MANDATORY REFERRAL NO. MR2024018

SILVER SPRING FIBER HUB

No. MR2024018

Completed: 7-15-2024

Figure 4 - Illustrative site plan

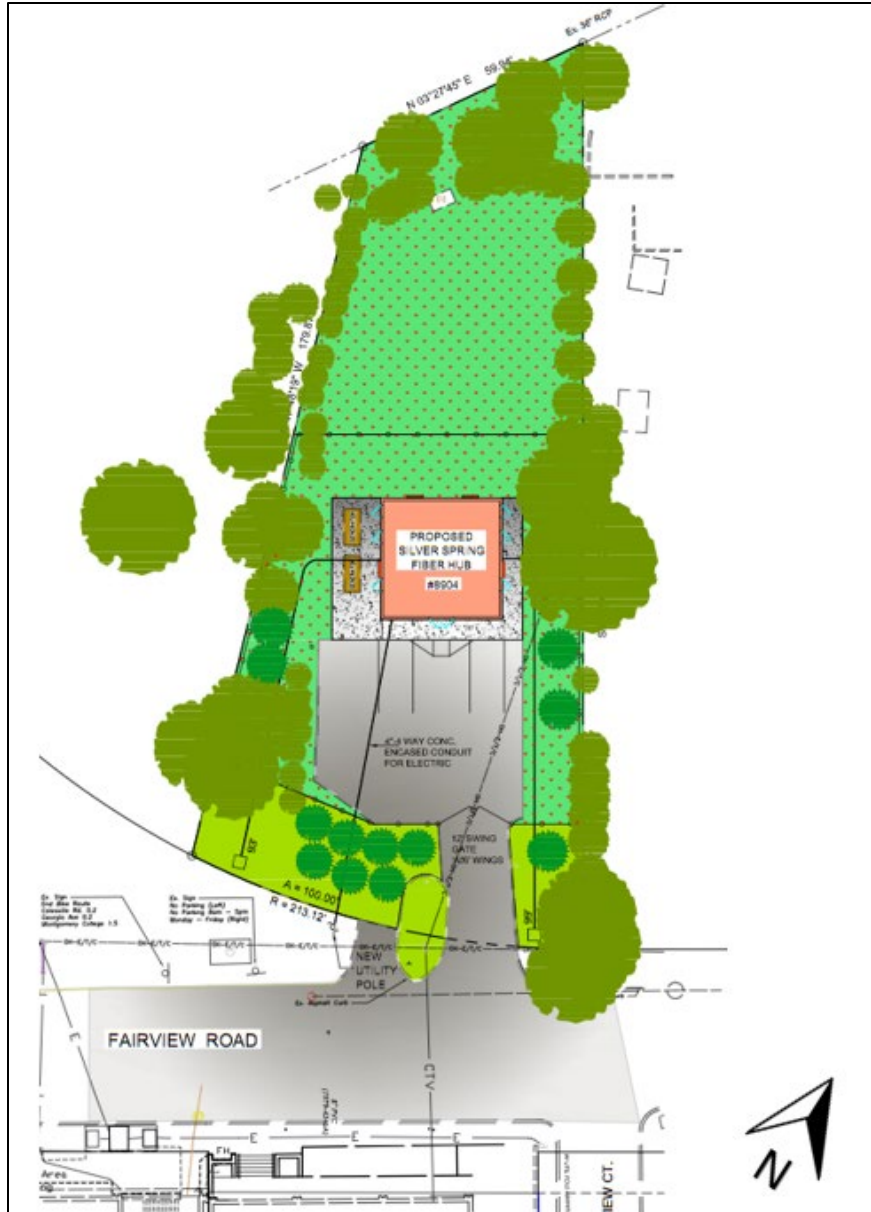
7. In conformance with the 2024 *Complete Streets Design Guide*, the Applicant is encouraged to improve Fairview Road, a Neighborhood Street, with a six-foot-wide (6 ft) sidewalk and a six-foot-wide (6 ft) street buffer along the Site frontage. The Applicant is strongly encouraged to extend the sidewalk to connect with the existing sidewalk on Spring Street, approximately 95 feet to the south.
8. In conformance with Chapter 49 of the County Code, the Applicant is encouraged to dedicate an additional five feet (5 ft) of right-of-way along the Site's frontage on Fairview Road to achieve the standard total width of sixty feet (60 ft).

10. Parks supports Planning Staff's recommendation for an improved sidewalk and street buffer. Parks further recommends that the Applicant consider expanding the project scope to include a 12-foot-wide curb cut and drive apron on Fairview Road to allow for the future repositioning of maintenance access and potential provision of ADA parking for park users to Fairview Road Urban Park from Fairview Road instead of the current locations along Spring Street.

11. Parks recommends that the Applicant coordinate any work along the Fairview Road right-of-way with Parks staff; such coordination would support Parks' goal of moving the existing maintenance access points on Spring Street to Fairview Road and potentially providing future ADA-compliant parking via the same new access point.
